REVISED RESPONSE TO REQUEST FOR ADDITIONAL INFORMATION

APR1400 Design Certification

Docket No. 52-046

RAI No.: 129-8085
SRP Section: 03.08.01 –Concrete Containment
Application Section: 03.08.01
Date of RAI Issue: 08/05/2015

Figure 5-4 Containment Pressure for Loss of RHR (Mode 5)

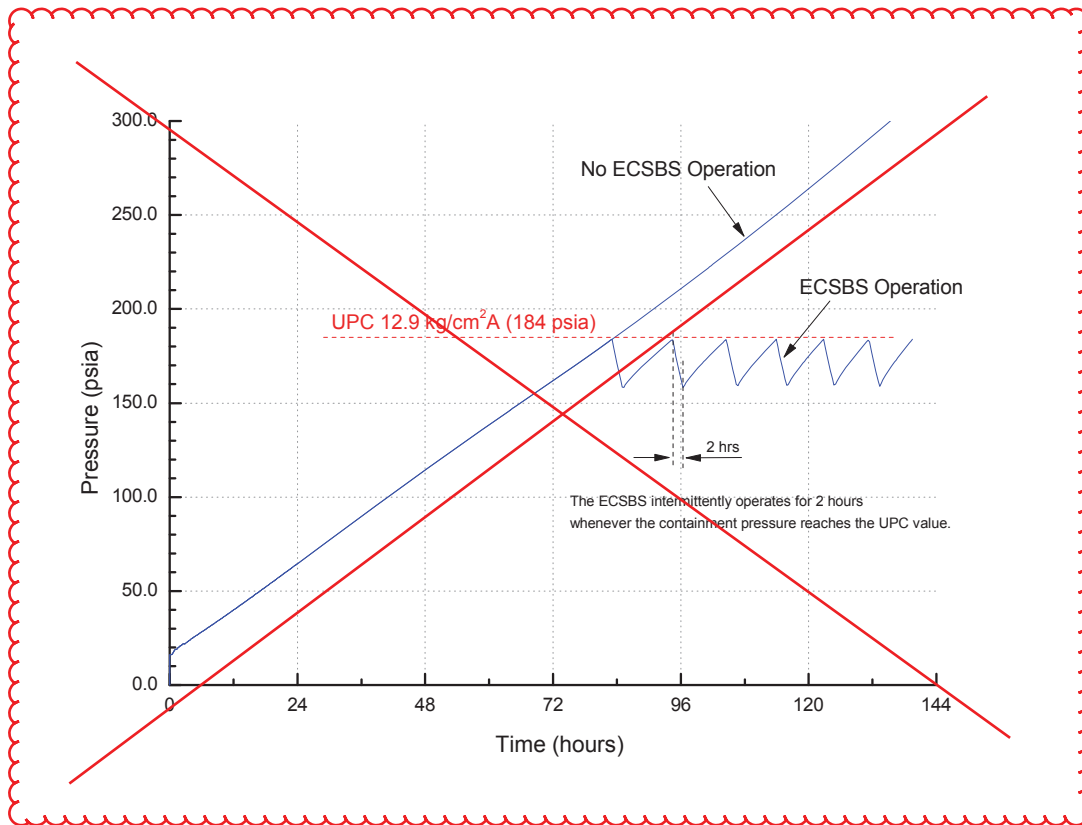
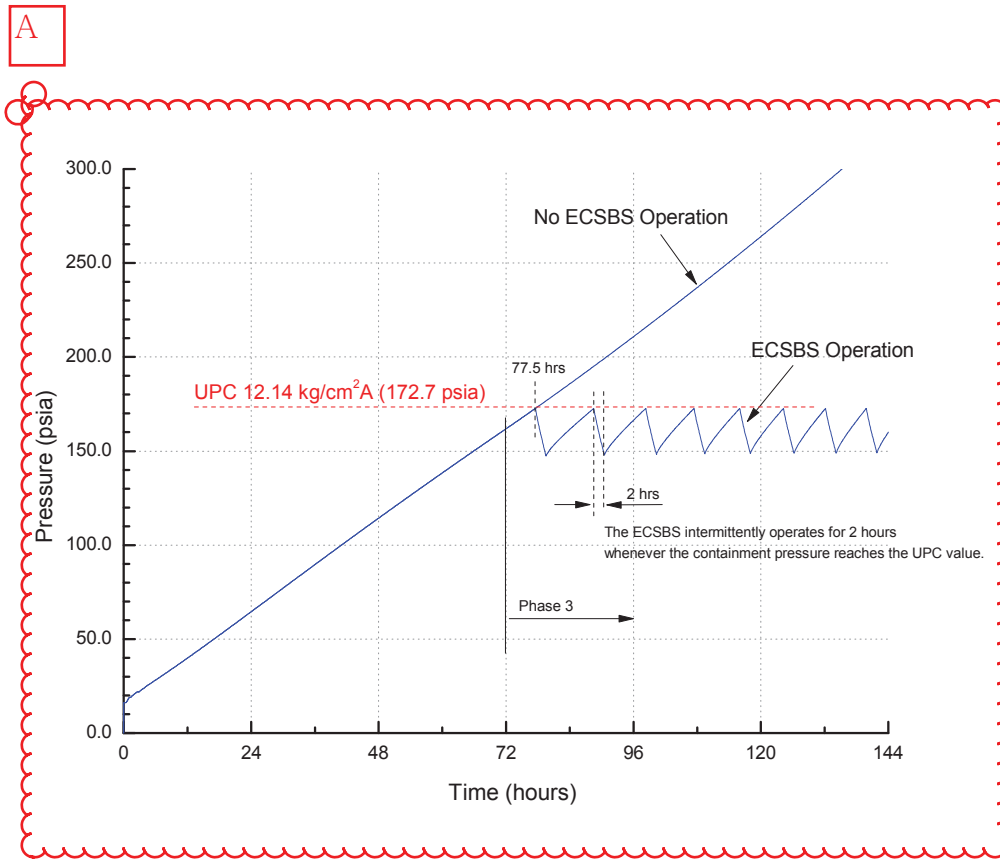
Replaced with next page, A

Due to the mass and energy released from the RCS, containment pressure increases consistently from the beginning of the event, but it can be maintained below UPC by operating the ECSBS intermittently after reaching UPC ~~at around 83 hours~~. The ECSBS is assumed to start spraying water into the containment atmosphere via a FLEX pump when the containment pressure reaches the UPC value of ~~12.9 kg/cm² A (184 psia)~~. After the initial operation, the ECSBS is assumed to be intermittently operated for 2 hours whenever the containment pressure reaches the UPC value. The FLEX pump provides the flow rate of 2,839 L/min (750 gpm) and the differential pressure of at least 2.8 kg/cm² (40 psi) at the ECSBS nozzle. The external water source for ECSBS operation is the RWT.

GOTHIC analyses are performed for evaluation of the containment pressure and temperature responses following loss of RHR in mode 5. Figure 5-4 shows that the containment pressure reaches the UPC value in about ~~3.5 days~~ without ECSBS operation, but with the intermittent operation of ECSBS, containment pressure can be maintained within the UPC limit. Figure 5-5 shows that the containment temperature is maintained well below 185 °C (365 °F), which is less than the upper limit temperature of 196 °C (385 °F) for ensuring the operability of RCS sensors.

Figure 5-5 Containment Temperature for Loss of RHR (Mode 5)

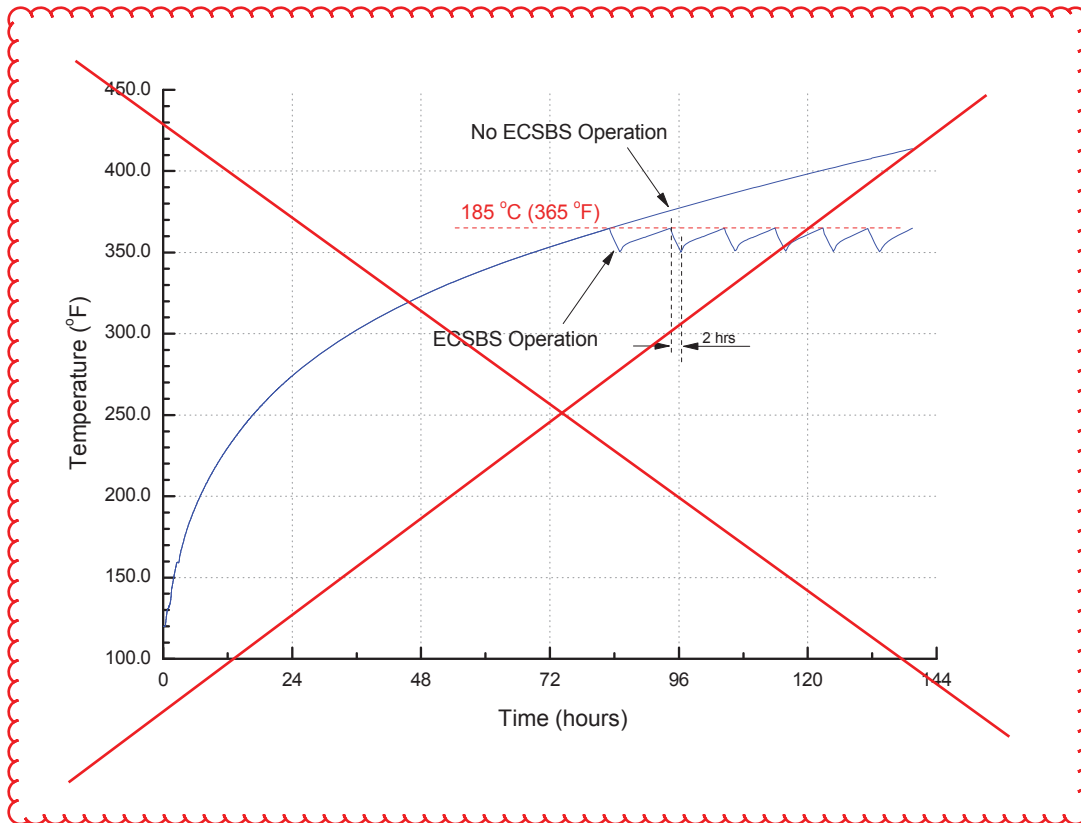
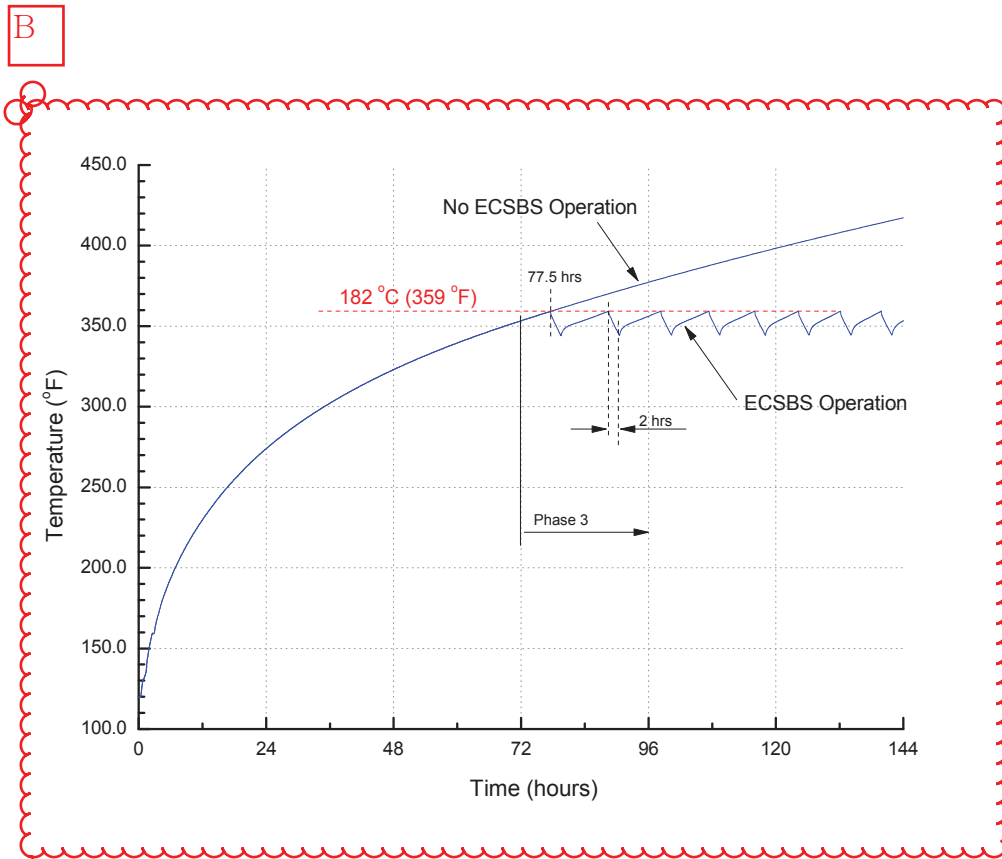
Replaced with next page, B
